**Chemung County Stormwater
Construction Inspection
Erosion and Sediment Control**

| Project Name Villa's at Gardner Road | Date 12/16/2021 |

| PROJECT: | Villa's Village of Horseheads Municipal Construction Inspection December 16, 2021 |

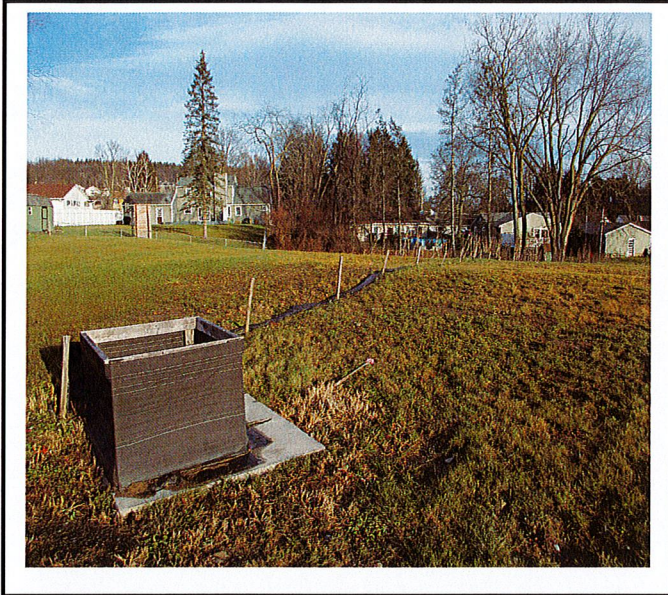
| -Remove silt fence between lot 6 & 4. Silt fence is off stakes and cannot be reused. |
| -Remove silt fence from drainage swale. |
| -Remove tree from drainage swale. |
